HISTORIC PRESERVATION COMMISSION STAFF REPORT

Address: 11 Montgomery Ave., Takoma Park **Meeting Date:** 1/10/18
Resource: Contributing Resource **Report Date:** 1/03/18
Takoma Park Historic District
Review: HAWP **Public Notice:** 12/28/17
Case Number: 37/03-18B **Tax Credit:** None
Applicant: Marianna Diggs **Staff:** Dan Bruechert
Proposal: Roof Solar Installation

The applicant proposes to install 16 solar photovoltaic panels on a racking system on the roof to the rear of the house.

SITE PLAN

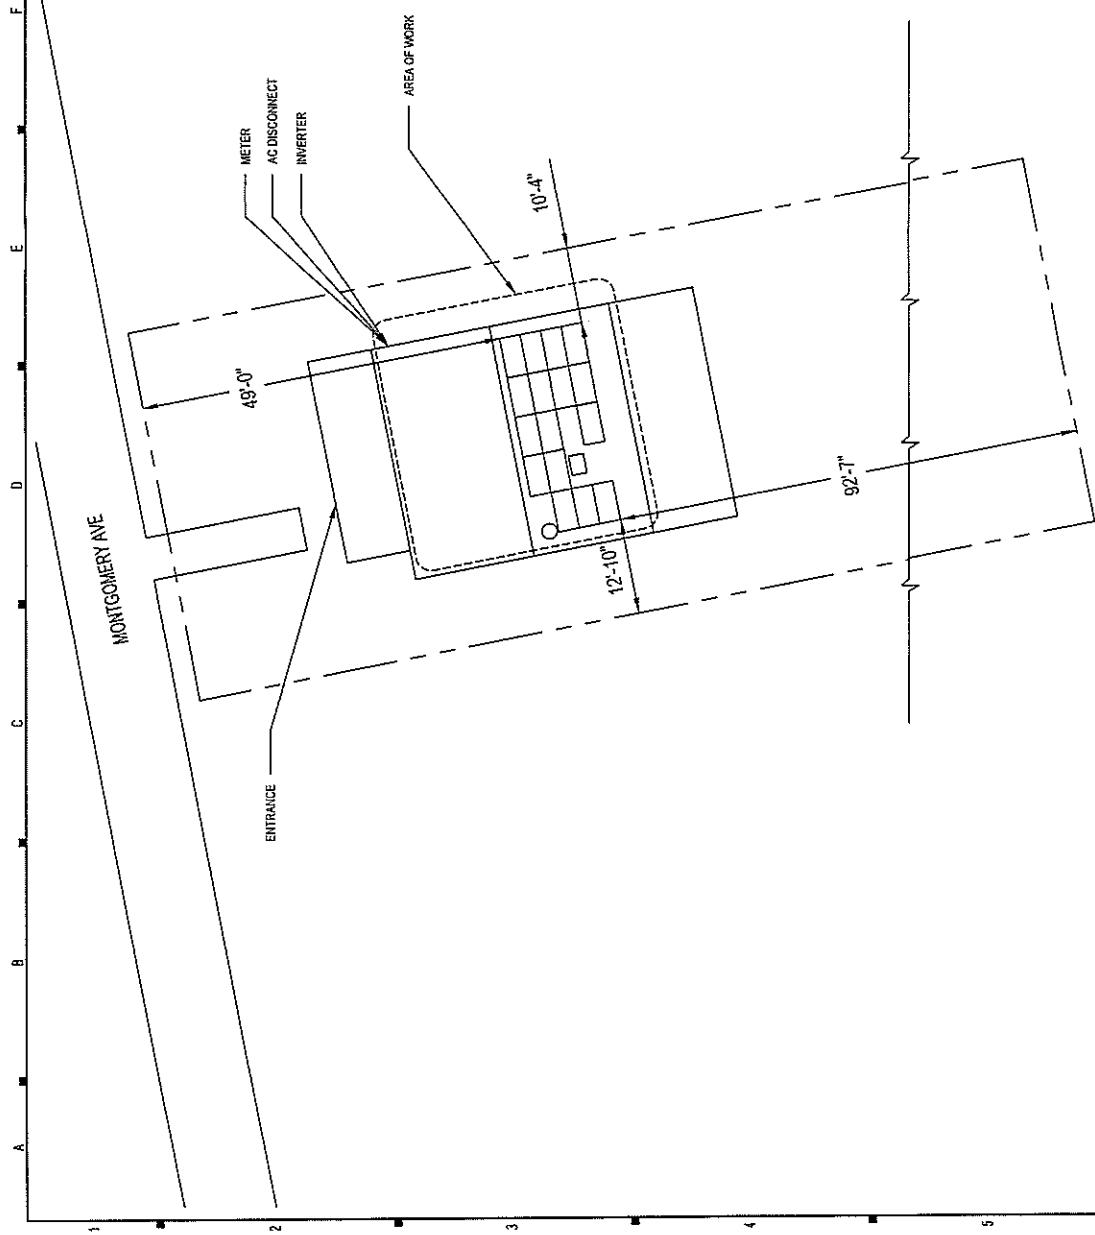
The applicant is proposing to install 16 solar panels on the roof. These photovoltaic panels will be installed on the back side of the gable roof in a single array. The panels all face south.

Because of the placement of these panels at the rear of the house, coupled with the narrow side setback of the neighboring properties, the proposed panels will not be visible from Montgomery Ave. and will have no impact on the streetscape. While Staff and the HPC have shown a preference for flush mounted solar voltaic panes, the *Design Guidelines* state that alterations to features on Contributing Resources that are not visible from the public right-of-way and do not affect the streetscape should be approved as a matter of course. Staff supports approval of this HAWP.

Staff recommends that the Commission **approve** the HAWP application as being consistent with Chapter 24A-8 and the Takoma Park Historic District Design Guidelines;
